IS 9137 (1978): Code for acceptance test for centrifugal, mixed flow and axial pumps - Class C [MED 20: Mechanical Engineering]

AMENDMENT NO. 4 SEPTEMBER 1989
TO
IS I 9137 - 1978 CODE FOR ACCEPTANCE TESTS FOR CENTRIFUGAL
MIXED FLOW AND AXIAL PUMPS — CLASS C

AMENDMENT NO. 2 JANUARY 1984
TO
IS : 9137 - 1978 CODE FOR ACCEPTANCE
TESTS FOR CENTRIFUGAL, MIXED FLOW
AND AXIAL PUMPS — CLASS C

AMENDMENT NO. 1 OCTOBER 1981
TO
IS : 9137 - 1978 CODE FOR ACCEPTANCE TESTS FOR
CENTRIFUGAL, MIXED FLOW AND AXIAL PUMPS — CLASS C

FIG. 10C CHARACTERISTIC CURVE FOR PUMP OF GUARANTEED DUTY OF 6 000 m³/h
DISCHARGE × m HEAD

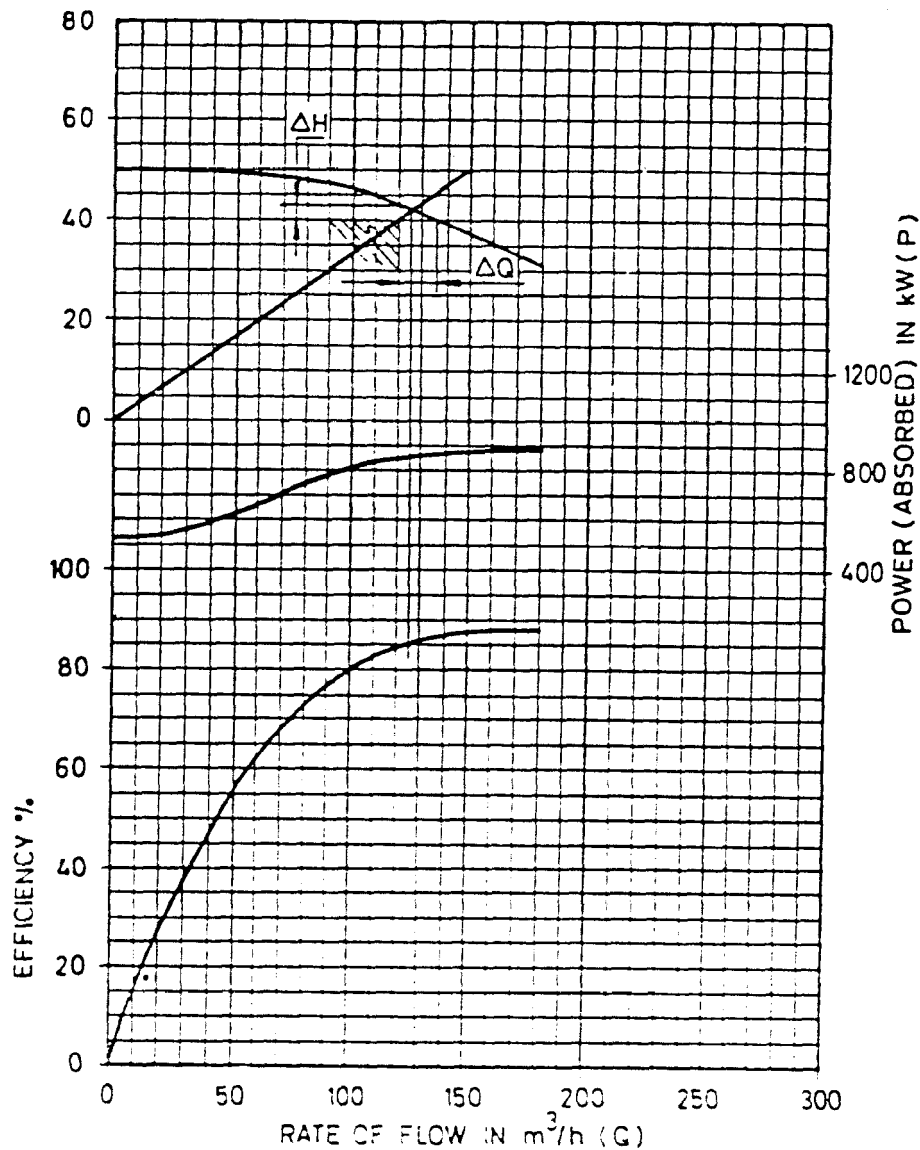
[Page 26, clause 9.6 (see also Amendment No. 1)] — Add the following examples in 9.6:

When pump fails to meet the guaranteed power input to the pump:

d) The duty point (6 000 m³/h, 41 m) is connected to (0,0) and the intersection of this line with the characteristic curve is determined which being 6 200 m³/h, 42 m. This duty considered as the actual pump duty has an efficiency of 84.5 percent.

e) Permissible lower limit on guaranteed efficiency (0.95×0.85) = 0.8075, that is, 80.75 percent. Since actual pump efficiency is 84.5 percent this is also within acceptable limits.

f) The power input to the pump within the range denned in 9.4.1 by the tolerances $\pm X_Q$ and $\pm X_H$ is 836.9 to 852.4 kW. As agreed between the manufacturer and the purchaser the power should not exceed 828 kW. Since the power input within the range exceeds 828 kW, the pump fails to meet the power consumption.

FIG. 10D CHARACTERISTIC CURVE FOR PUMP OF GUARANTEED DUTY OF $300 \text{ m}^3/\text{h}$
DISCHARGE $\times 7.5 \text{ m}$ HEAD

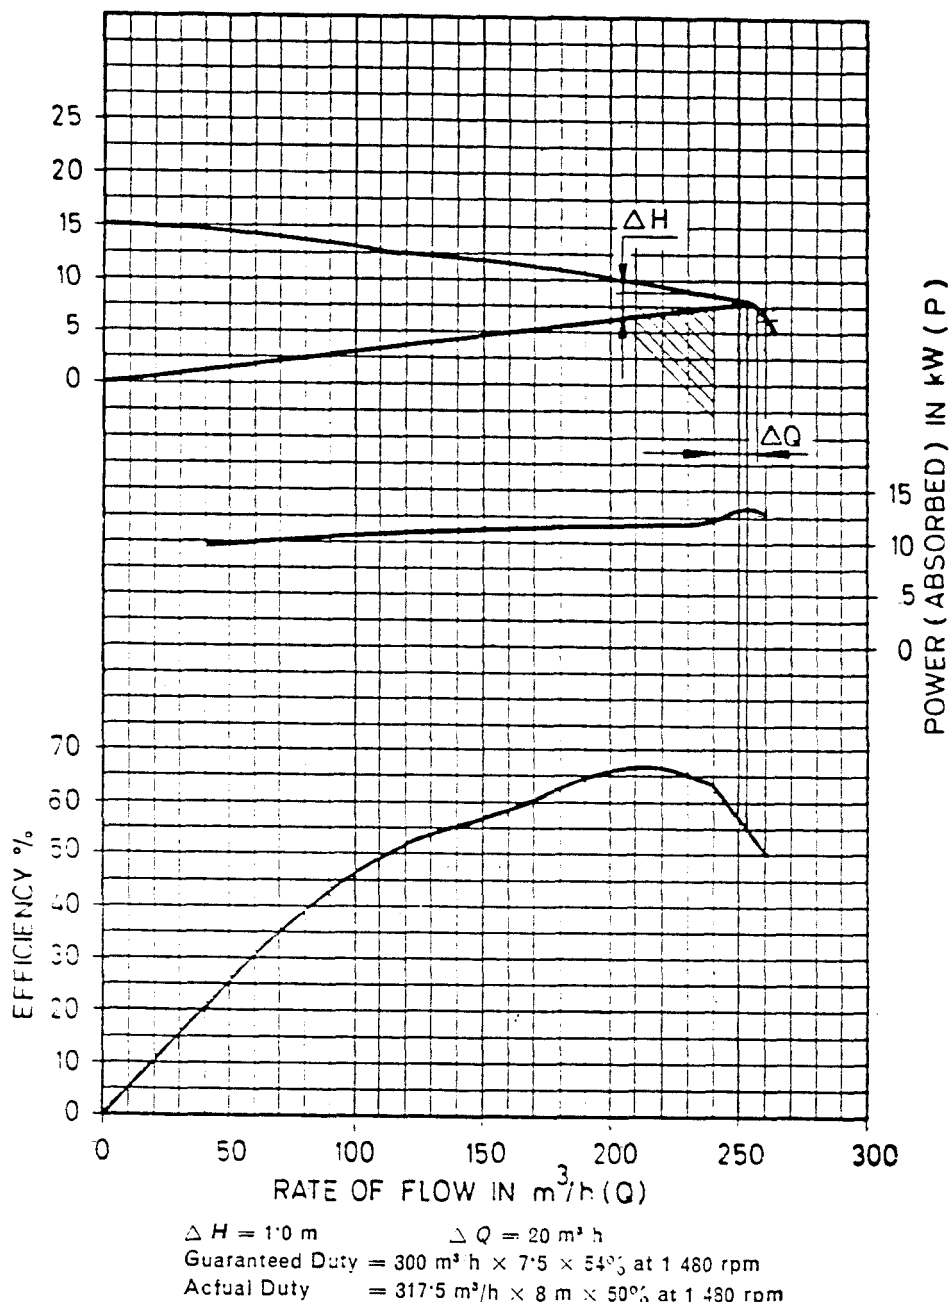
Example 4:

When pump fails to meet the guaranteed efficiency point;

- d) The duty point ($300 \text{ m}^3/\text{h}$, 7.5 m) is connected to ($0,0$) and the intersection of the line with the characteristic curve is determined which being ($317.5 \text{ m}^3/\text{h}$,

8.0 m). This duty considered as the actual pump duty has an efficiency of 50 percent.

- e) Permissible lower limit on guaranteed efficiency (0.54×0.95) = 0.513 , that is, 51.3 percent. Since the actual efficiency is 50 percent the pump fails to meet the guaranteed efficiency.
- f) The power input to the pump within the range defined in 9.4.1 by the tolerance $\pm X_Q$ and $\pm X_H$ is 11.98 kW to 13.35 kW. Since the power input as agreed between the manufacturer and the purchaser lies within this range, the power consumption is within acceptable limits.

FIG. 10A CHARACTERISTIC CURVE FOR PUMP OF GUARANTEED DUTY OF 1 000 m³/h DISCHARGE × 50 m HEAD

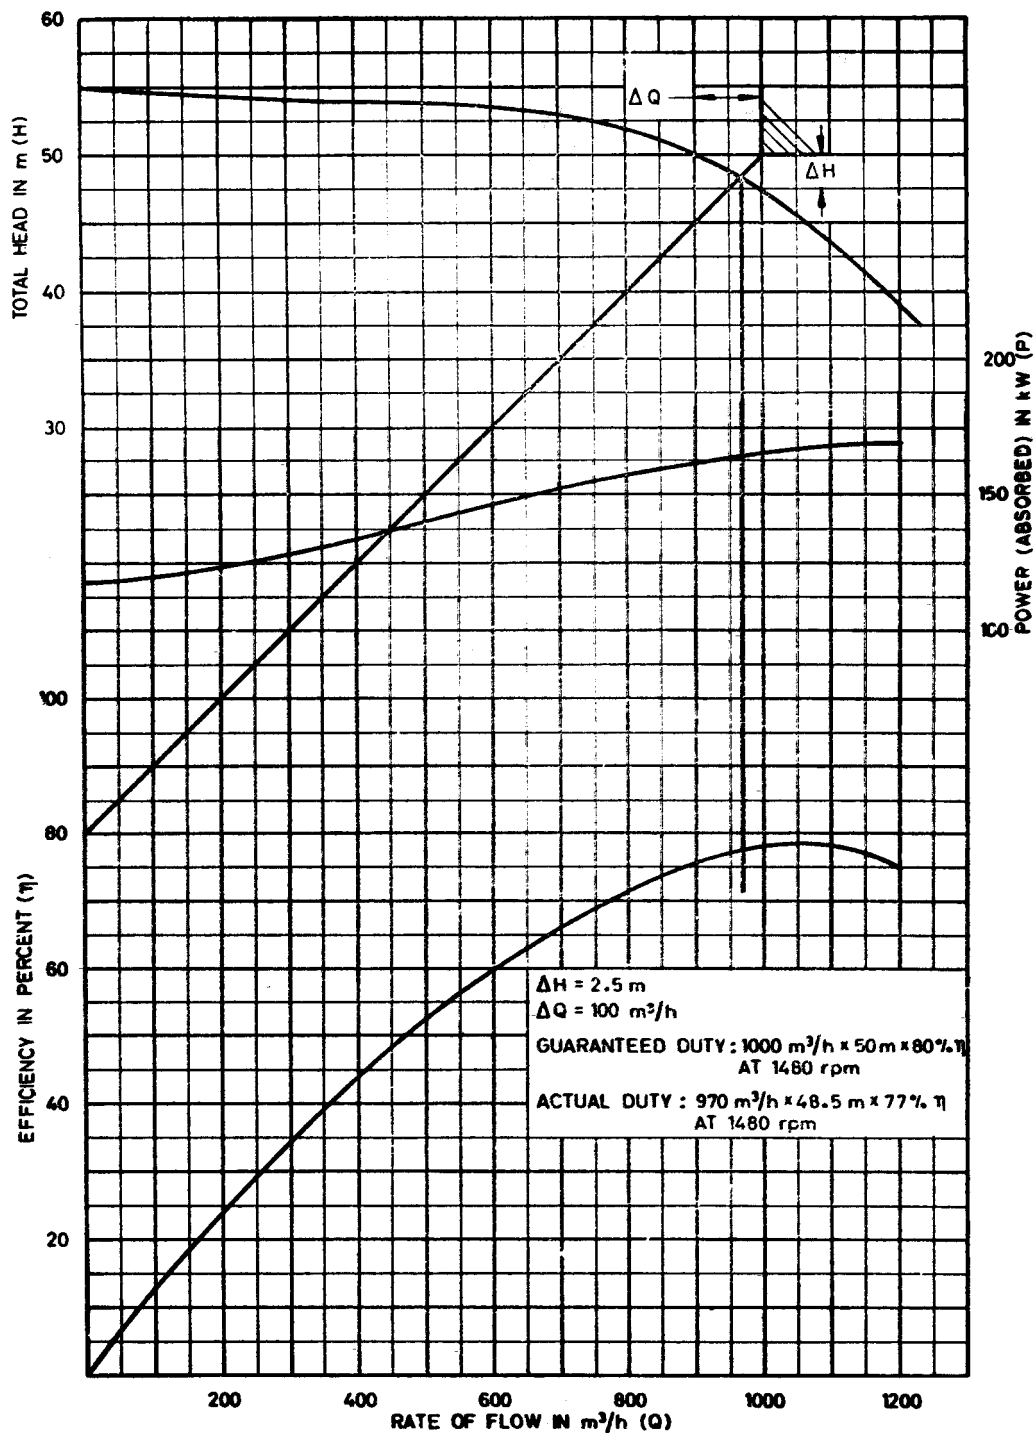
(Page 26, clause 9.5) — Add the following new clause after 9.5:

'9.6 The worked out examples indicating the application of the formula as given in 9.4.1 are given below:

d) The duty point (1 000 m³/h, 50 m) is connected to (0, 0) and the intersection of this line with the characteristic curve is determined which being (970 m³/h, 48.5 m). This duty, considered as the actual pump duty has an efficiency of 77%.

e) Permissible lower limit on guaranteed efficiency $(0.95 \times 0.8) = 0.76$, that is, 76%. Since actual pump efficiency is 77% this is also within acceptable limits.

FIG. 10B CHARACTERISTIC CURVE FOR PUMP OF GUARANTEED DUTY
OF $200 \text{ m}^3/\text{h}$ DISCHARGE $\times$ 25 m HEAD

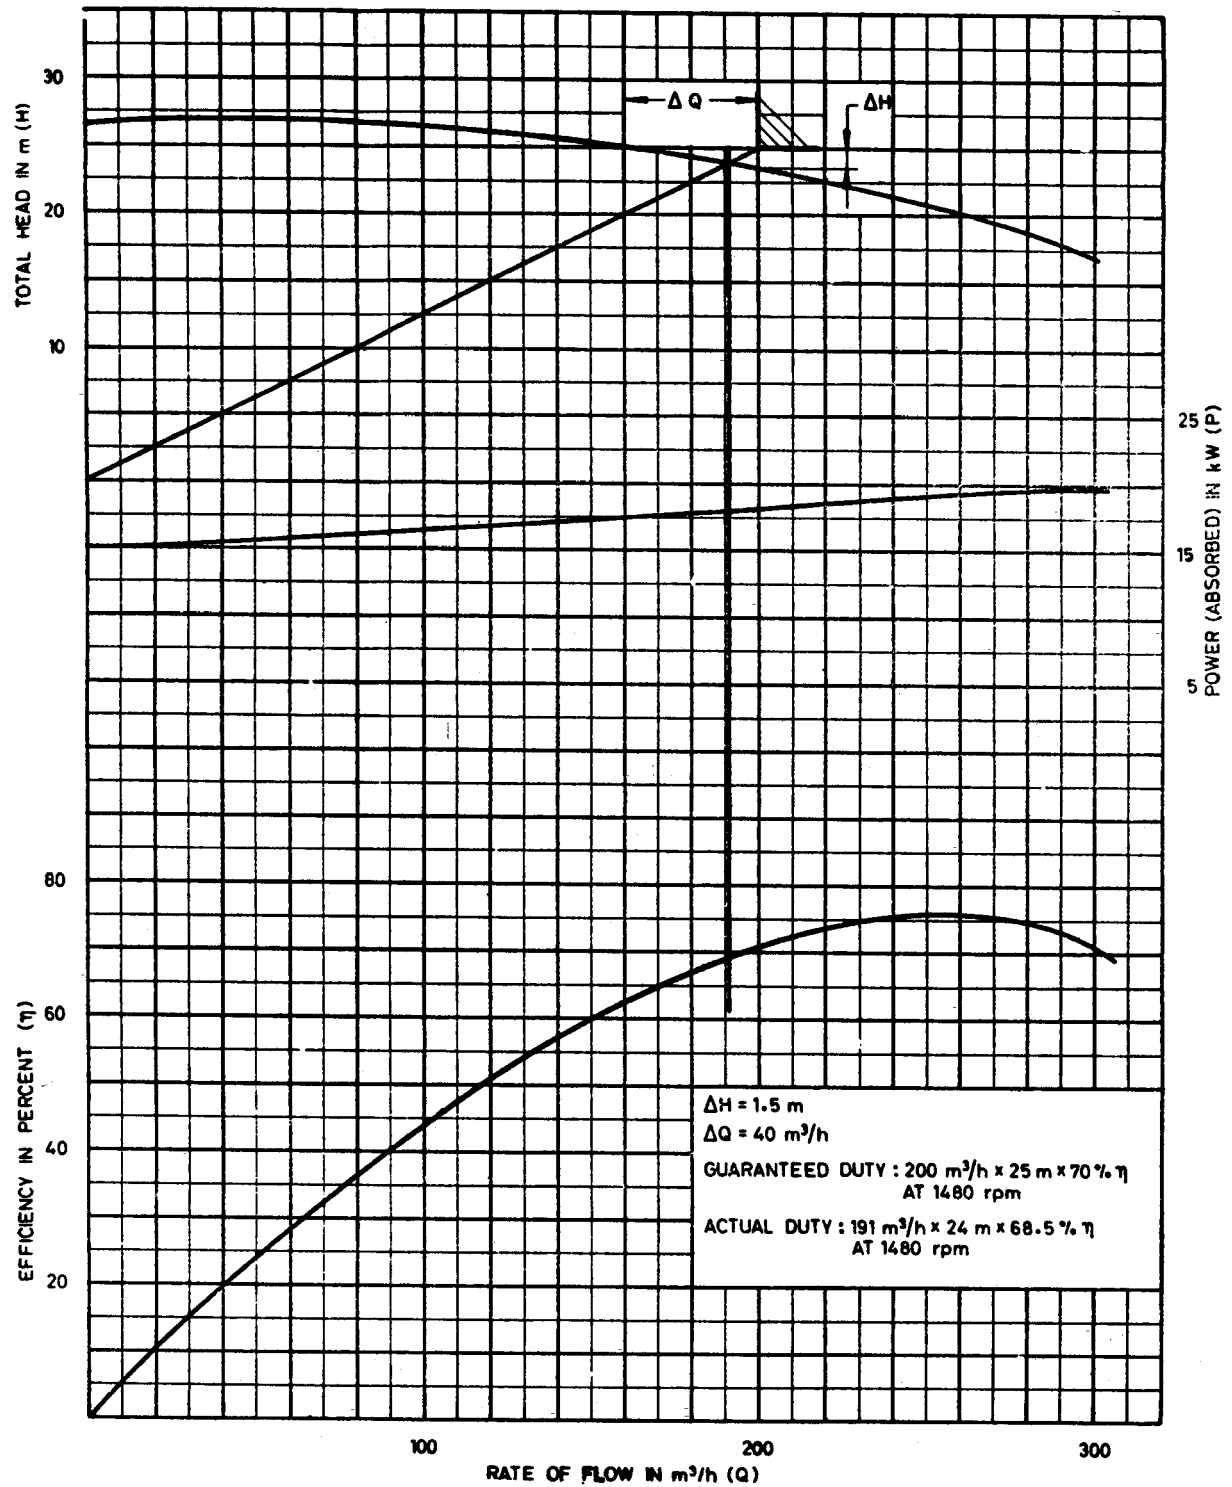
Example 2:

Hence, the pump characteristic is not within acceptable limits,

d) The duty point (200 m³/h, 25 m) is connected to (0, 0) and the intersection of this line with the characteristic curve is determined from the graph which being (191 m³/h, 24 m). This duty considered as the actual pump duty has an efficiency of 68.5%.

e) Permissible lower limit on guaranteed efficiency is $0.95 \times 0.7 = 0.665$, that is, 66.5%. Since actual pump efficiency is 68.5%, this is within acceptable limits.
